# UNITED STATES PATENT AND TRADEMARK OFFICE

APPLICATION NO.	FILING DATE	FIRST NAMED INVENTOR	ATTORNEY DOCKET NO.	CONFIRMATION NO.
10/817,564	04/01/2004	David S. Graham	GRAMP005/P06002	3810
22434	7590	01/31/2007	EXAMINER	
BEYER WEAVER LLP			NGUYEN, JIMMY H	
P.O. BOX 70250			ART UNIT	
OAKLAND, CA 94612-0250			PAPER NUMBER	
			2629

**Office Action Summary**

### **DETAILED ACTION**

**FIG. 1**

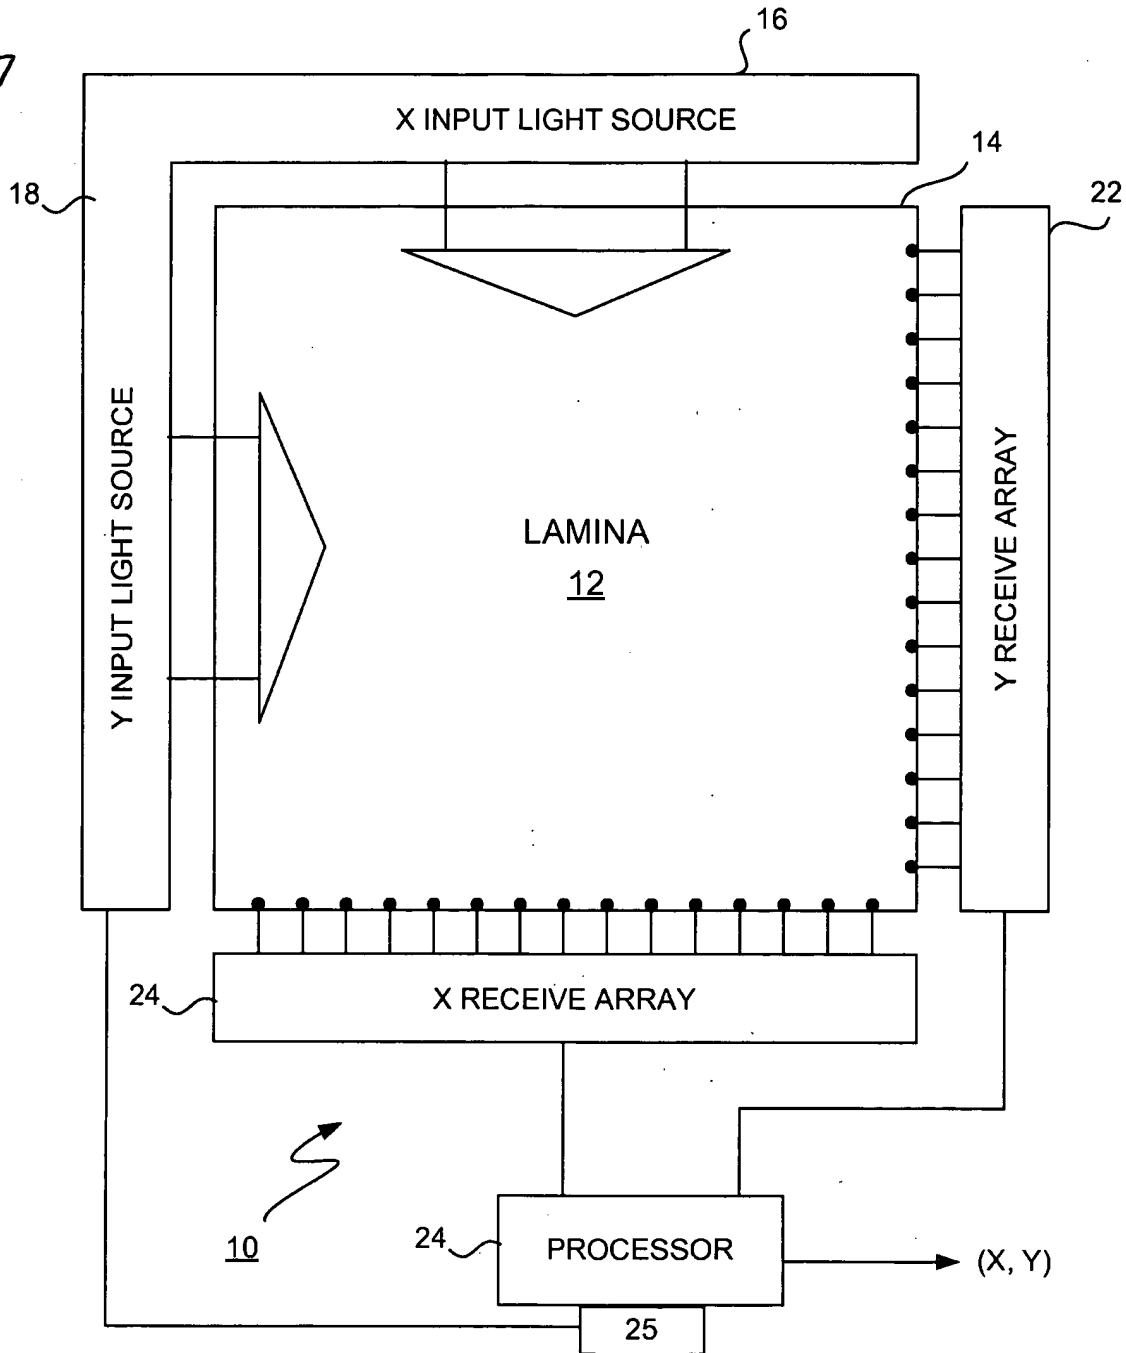
3. The replacement drawing was received on 12/20/2006. This drawing is not acceptable because there is nowhere in the original disclosure to teach the location of the element 25 as shown in the replacement sheet of Fig. 1. Also, note that reference character "24" has been used to designate both "X receive array" and "Processor".

With respect to the drawing objection for failing to show the limitation, “a sleep mode element” of claim 23 in the Office action dated 11/13/2006, Applicant amended Fig. 1 to show a sleep mode element 25. In order to avoid a new matter added to the original disclosure, Examiner withdraws this objection. See the drawing disapproval above.

Disapproved  
JHN  
1/24/2007
